PART NUMBER INFORMATION:

SERVICE INSTRUCTIONS:

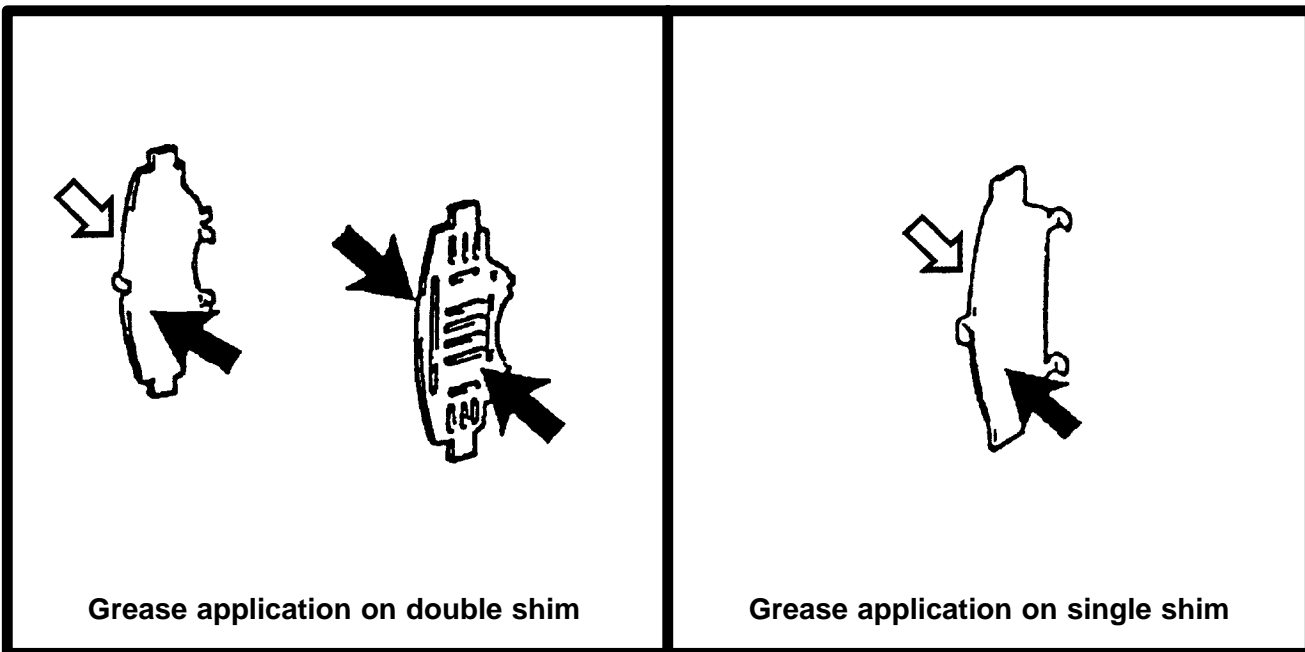
- 1) All vehicles are to be inspected to insure that the integrity of the complete brake system is maintained. When replacing worn pads, you **should** replace the shims, wear indicators, (wear indicators may be riveted onto pads for some models) and shim grease at the same time. Vehicles found to need extensive hardware replacement, including anti-squeal springs and support plates, should be repaired using the full pad kit which includes all hardware components.
- 2) When applying shim grease, apply a thin layer over the shim faces as indicated below.

-  = Apply shim grease on this face
-  = Do not apply shim grease on this face (piston side).

NOTE: The new shim grease (P/N: 08887-80409) is a dark gray color instead of the current gold color.
